CO3275 – Northfield BF 0241(58)

ADDENDUM #2

Changes have been made to the documents located on the Bid Opportunity website as noted below:

DECK REINFORCEMENT PLAN

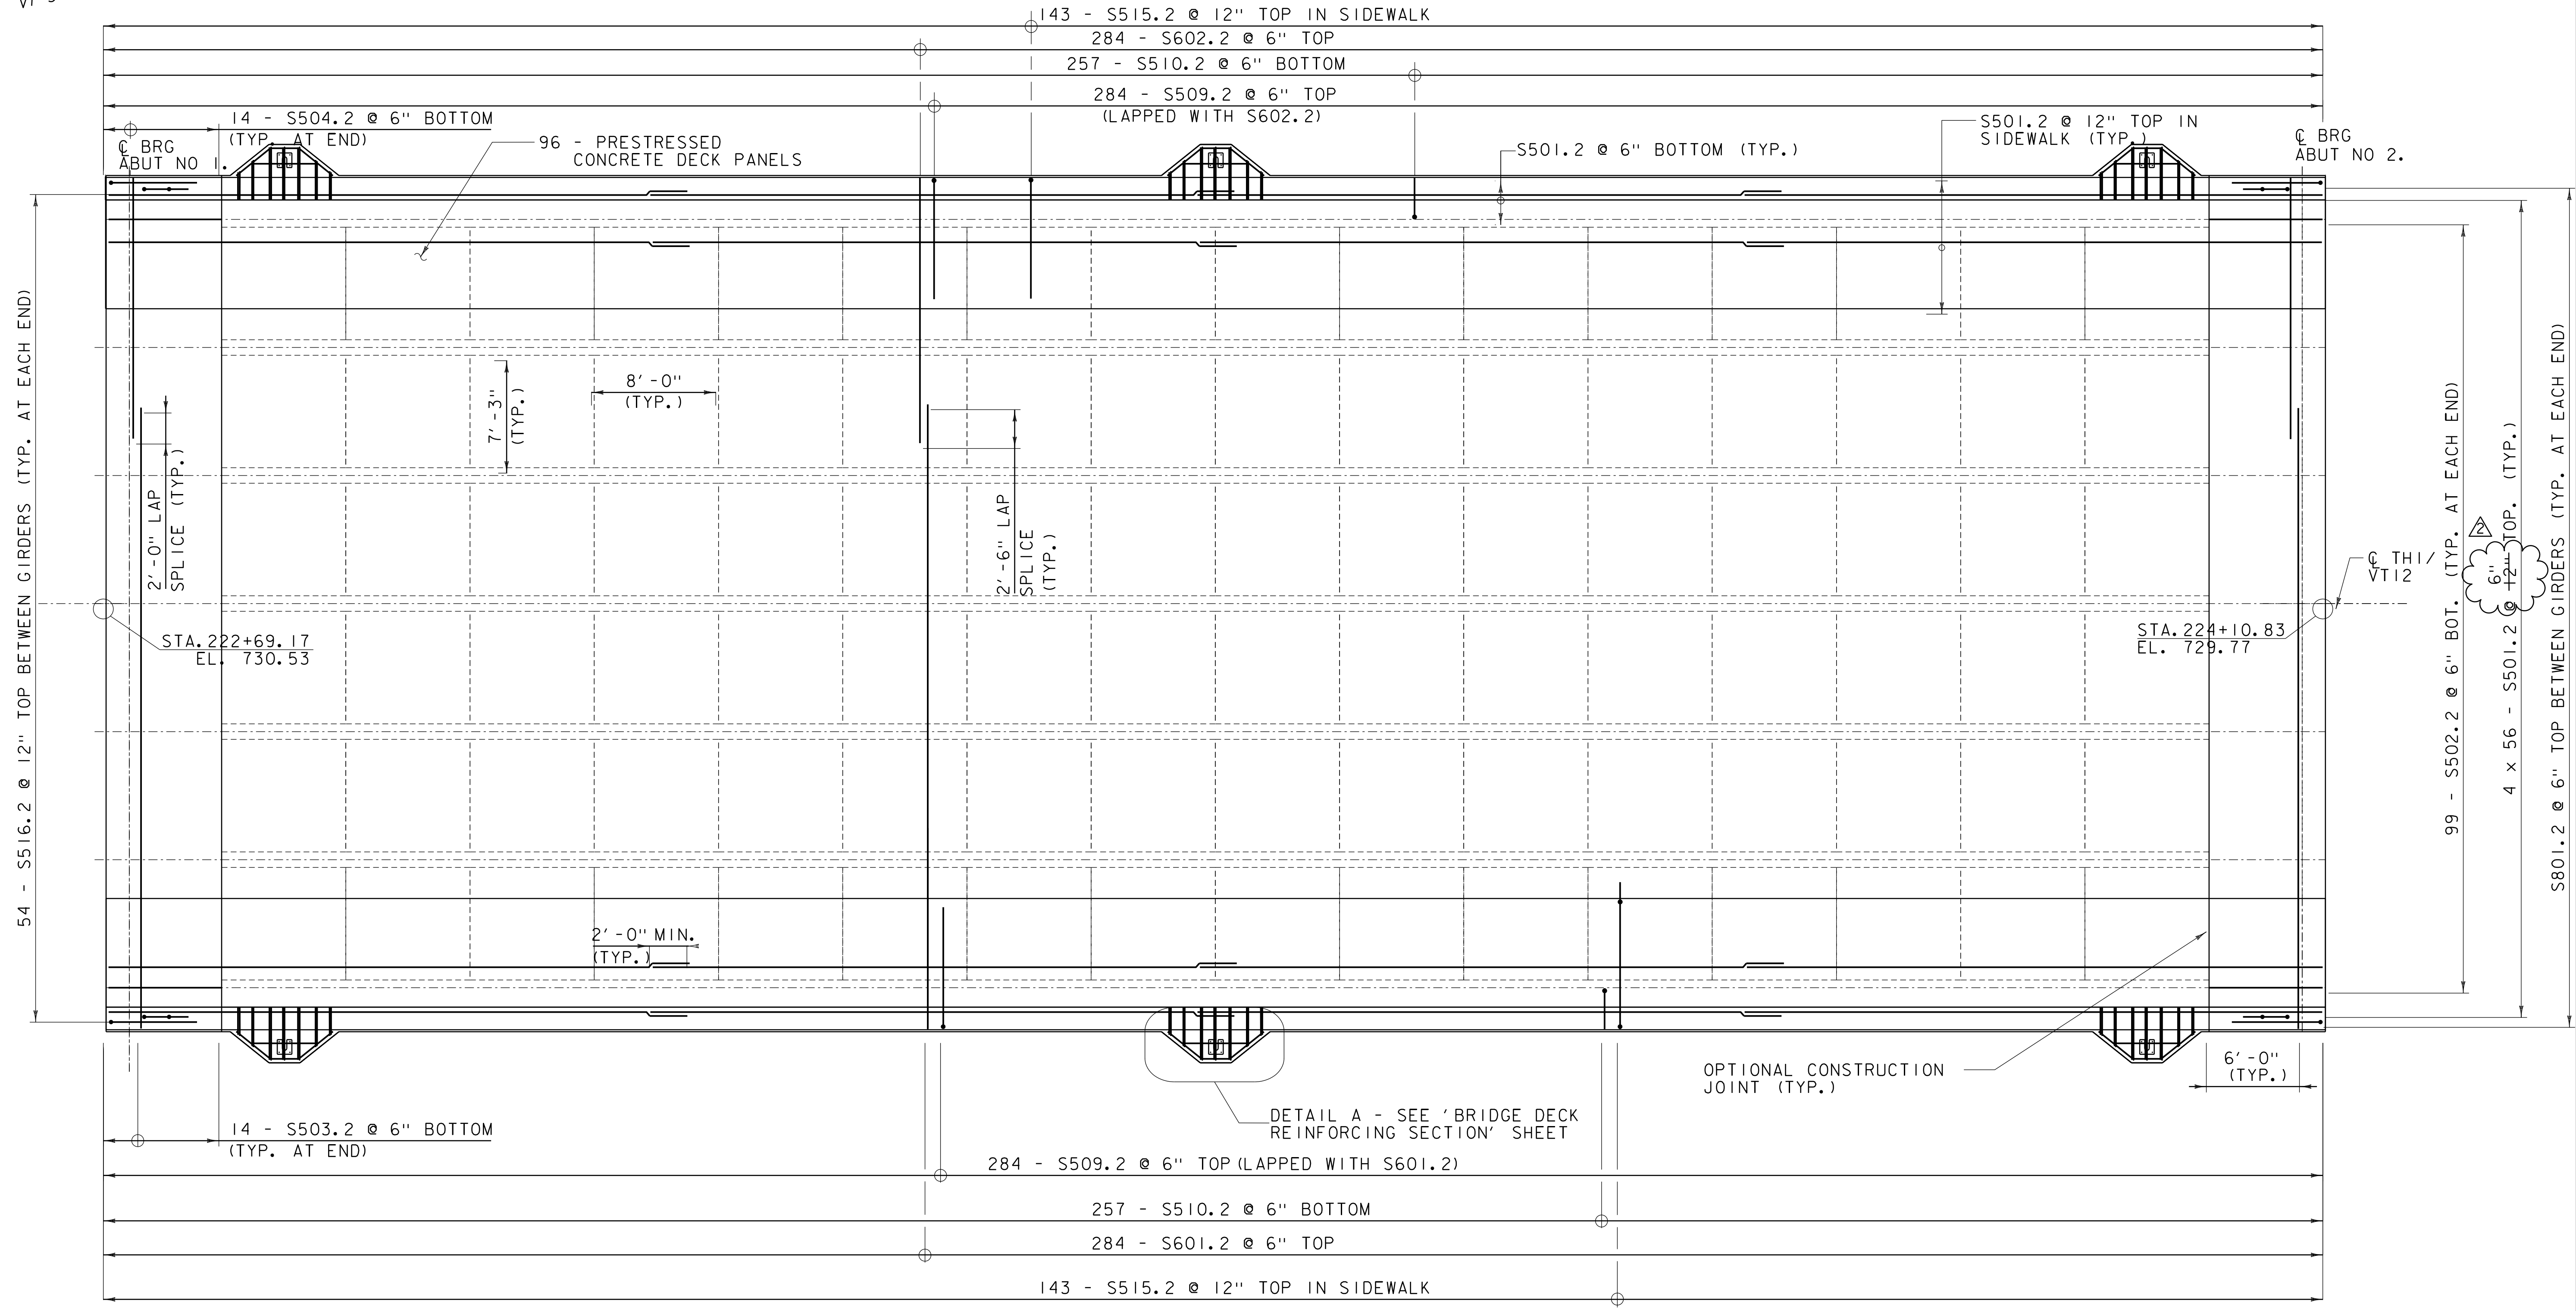
ADDENDUM	REVISION	PLOT DATE	DESCRIPTION	BY
△	1	14-MAY-2026	REINFORCING REVISED	S. BROWN
